## REMARKS

Claim 1 stands rejected under 35 USC 103(a) as obvious in view of Schwarte (WO 98/10255) when read with Lambeth (US 4,826,312). The Schwarte reference has been provided by the Examiner with only its abstract translated into English. Rudolf Schwarte (WO 98/10255) is the applicant in this application.

Fig. 1

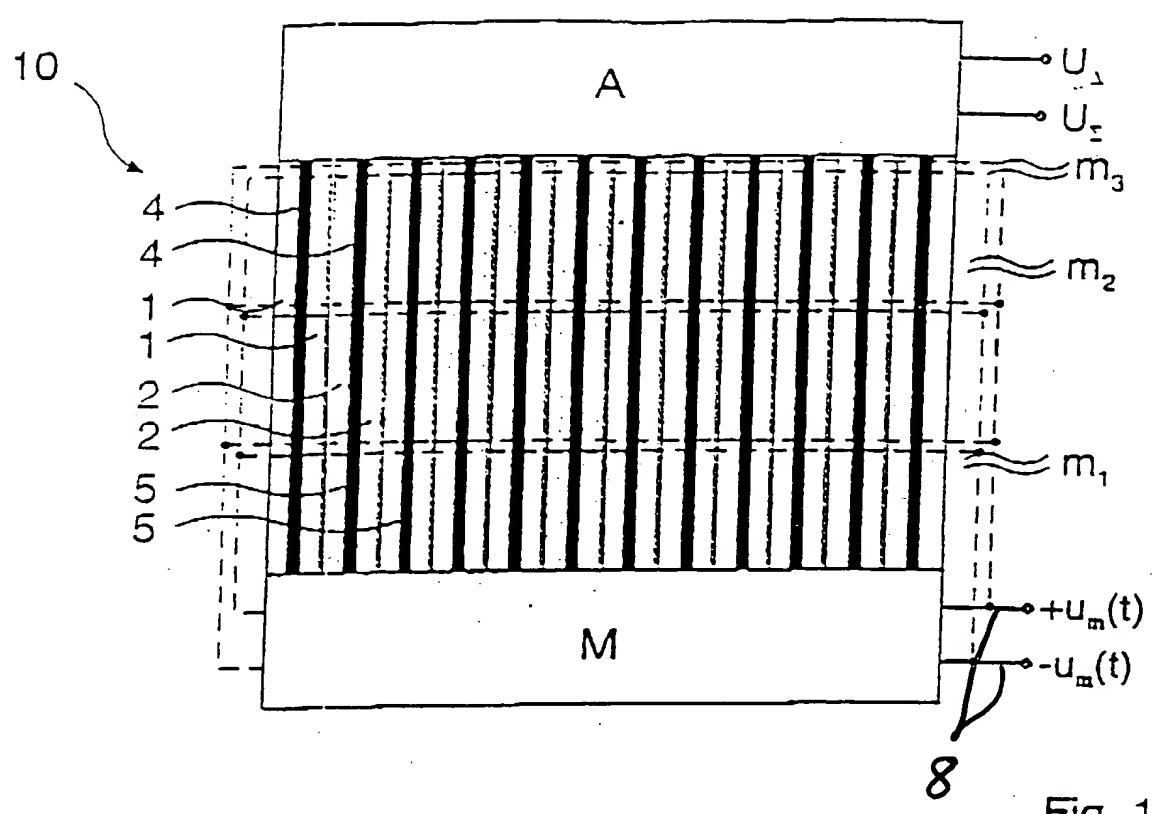
The drawings stand objected to for failing to include the numeral "8" in Figure 1 and numeral 15 in Figure 10 to be consistent with the discussion in the specification. The drawings have been amended to add these numerals. The drawings also stand objected to for showing the numeral "36" in Figure 11 and the numeral "46" in Figure 12 without corresponding discussion in the specification. These numerals "36" and "46" have been removed from the drawings. A marked-up copy of the drawings is attached. A substitute set of formal drawings is also attached. The standing 37 CFR 1.84(p)(5) objection has now been overcome.
